AIRWORTHINESS DIRECTIVE

Inspection/replacement of connection bolts for elevator and airbrakes. i.e. rigging pins

Technical Note 104 - 18

Bergfalke II, II-2,
III, IV

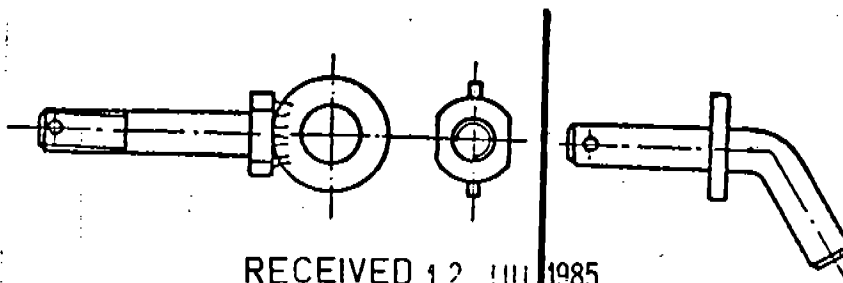
Not affected are (these bolts are already made of "Aircraft steel"):

- a) "halfautomatic" elevator connection bolts (the bolt slides in a tube which is welded to the elevator lever).
- b) elevator connection bolts in the following construction

Instruction 3

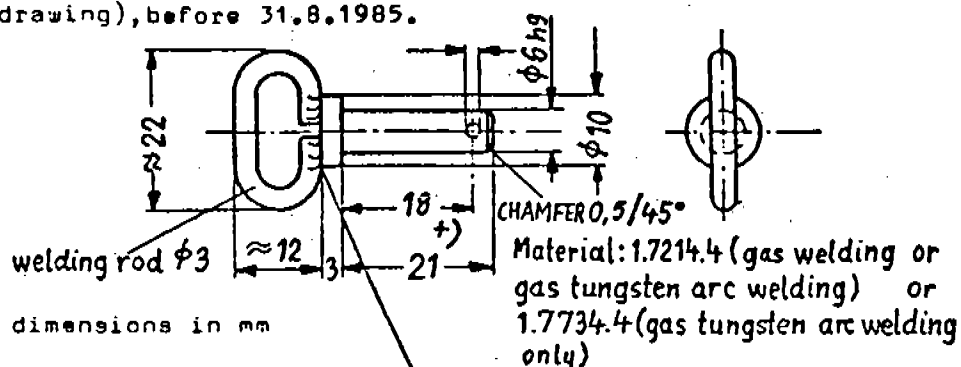
If the connection bolts are not made of "Aircraftsteel", they must be replaced against such of aircraftsteel (see drawing), before 31.8.1985.

here as difference to the eyebolt (from DIN material) no

- +) a certain amount of Bergfalke are "amateur-build".
Therefore there may be differences in the length of the bolts, and they must be fitted to the actual Bergfalke. In any case with the new connection bolts the controls must be checked carefully on function and clearance.

For the manufacture of a new pin use 4130 steel condition 'N' The handle can be made from steel welding rod as in the drawing Instruction 3 and can be gas or T.I.G. welded. On no account should it be brazed.

Material: see drawing under Instruction 3
